COMMON STRUCTURAL RULES FOR  
BULK CARRIERS

Stress concentration factor for the hatch corners

## Doubts in the CSR bulk formula ( $K_{gh}$ )

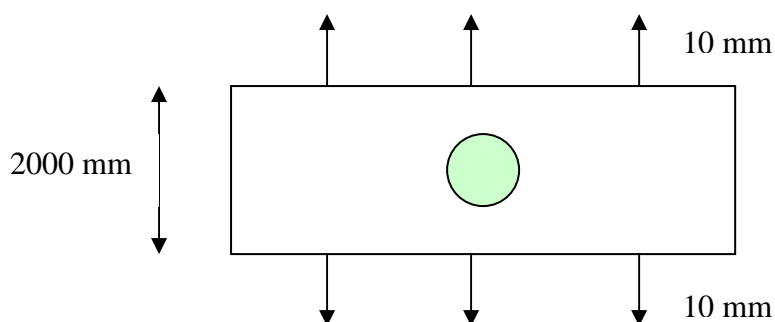
In the bulk formula,  $r_a$  is used for rounded corners (the radius in major axis) as a basis for elliptic corners. They attribute a correction factor to take into account the influence of elliptic shape.

with the following correction factor to apply to get the elliptic stress concentration factor from the rounded one:

$$f_c = \frac{1}{3} + \frac{2r_b}{3r_a}$$

*This correction factor gives the ratio of stress concentration for the tension of an infinite width thin element with an elliptic hole to that with a circular hole. In this equation,  $r_a$  denotes the radius in major axis and  $r_b$  denotes the radius in minor axis. This correction factor can be applied to the stress concentration factor for the fillet shoulder with circular arc shape of radius  $r_a$ .*

Dimensions of the compared ellipses

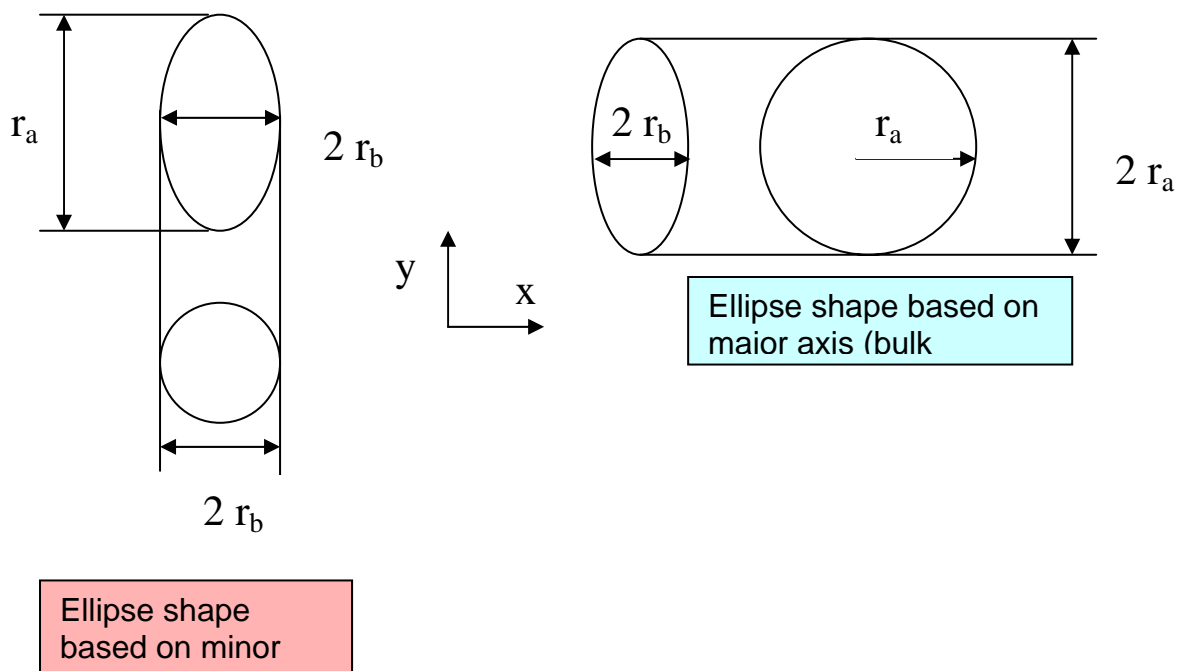
We test the correction factor with ANSYS 9.0 finite element software. We used shell elements of 10 mm thickness. We model plates of 2 by 6 meters with holes in the middle and impose displacements of 20 mm in the small direction as shown in the figure below. We use a 206000 MPa Young modulus and a 0.3 Poisson ratio.

We compare six different shapes to the circular one.

Ellipse shapes 4, 5 and 6 are other kind of ellipse shape that those used for bulk formula. The reference axis is the minor one.

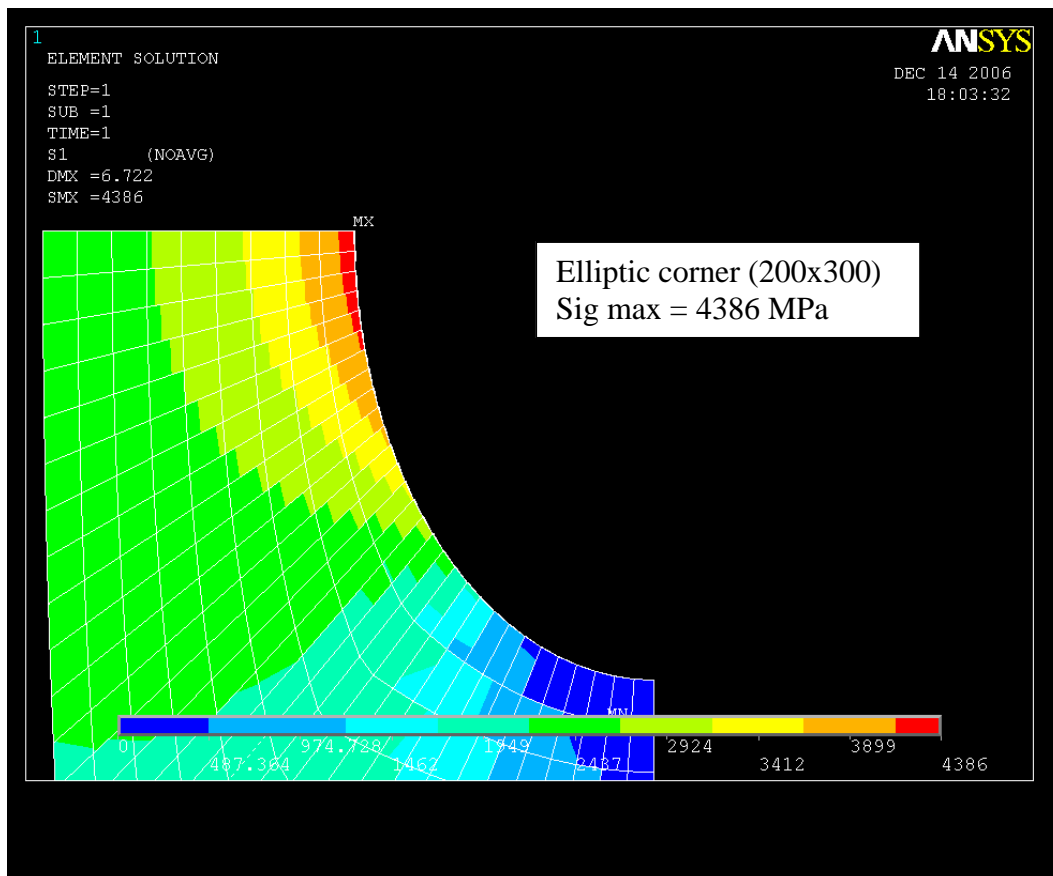
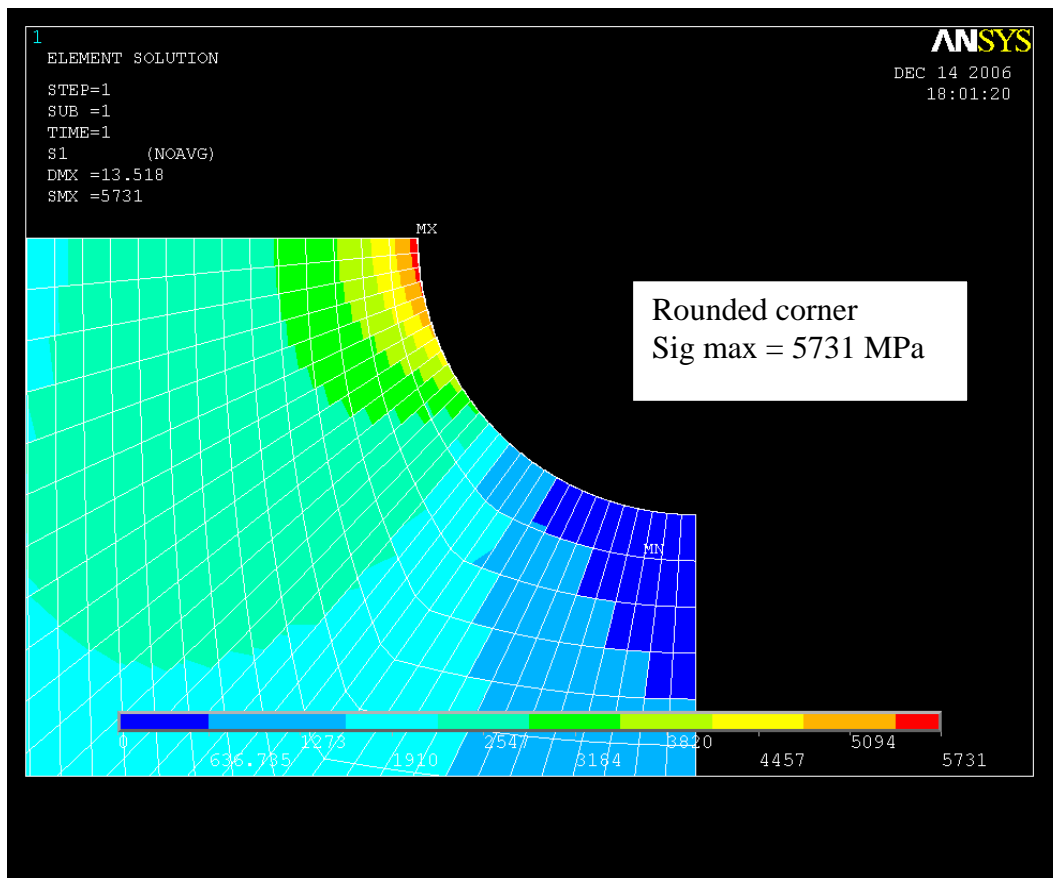
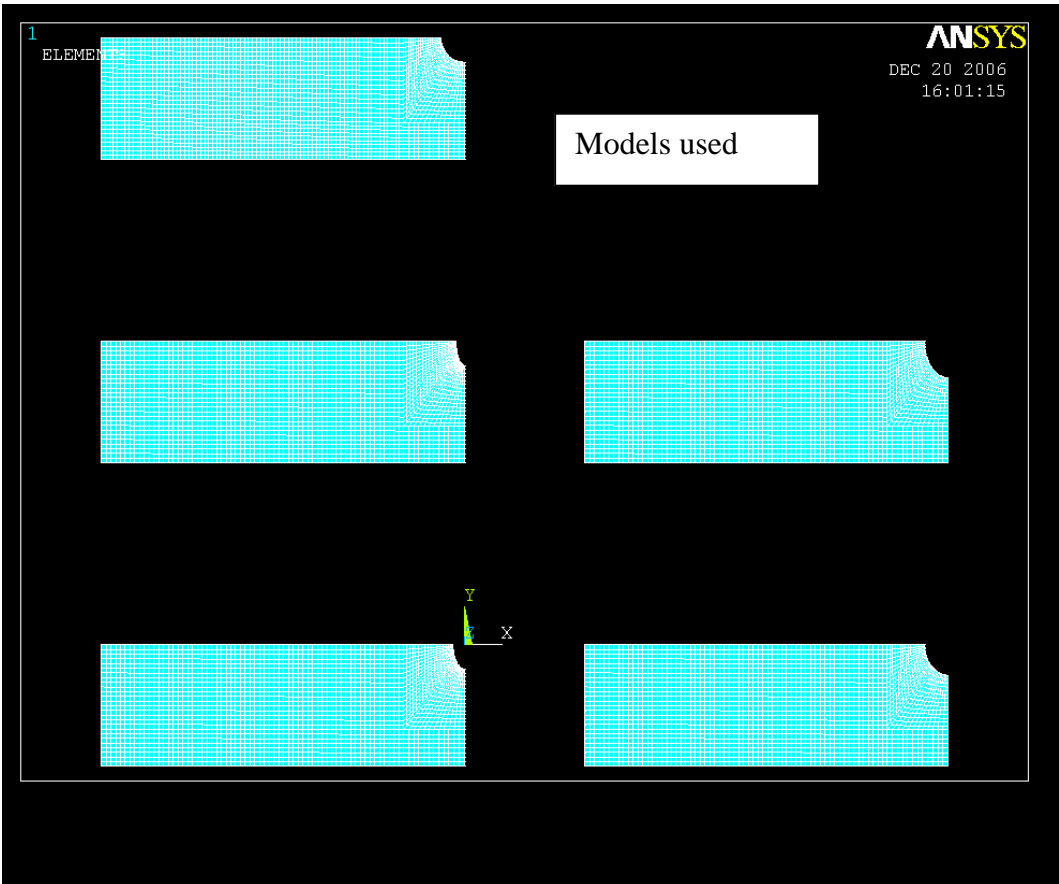
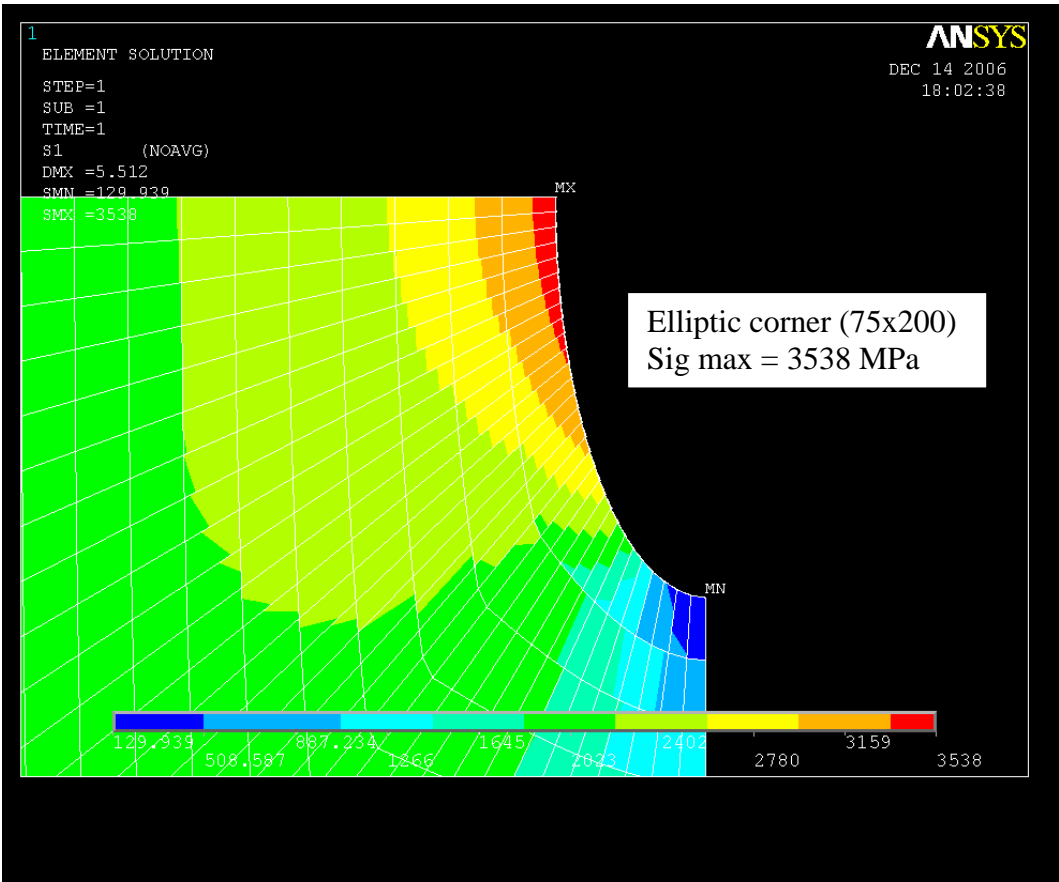
This is the greatest principal stress read in the model as shown on the following pictures.

Shape	dimensions	Maximum stress	$K_t$ real (Max stress/2060)	Correction factor $f_c$	$K_t$ evaluated ( $2.78 * f_c$ )	$K_t$ eval / $K_t$ real
Circular hole	200x200	5731	2.78	1		
Ellipse 1	50x200	3057	1.48	0.5	1.39	0.94
Ellipse 2	75x200	3538	1.72	0.58	1.62	0.94
Ellipse 3	100x200	4009	1.95	0.67	1.85	0.95
Ellipse 4	200x250	4928	2.39	0.87	2.42	1.01
Ellipse 5	200x300	4386	2.13	0.78	2.17	1.02
Ellipse 6	200x400	3702	1.8	0.67	1.85	1.03

We can see that  $r_b$  radius is a more conservative basis than  $r_a$  to evaluate the influence of an elliptic shape. The error is a bit less than for  $r_a$  and the  $K_t$  obtained is over evaluated ( $r_b$  basis) instead of being under evaluated ( $r_a$ ).
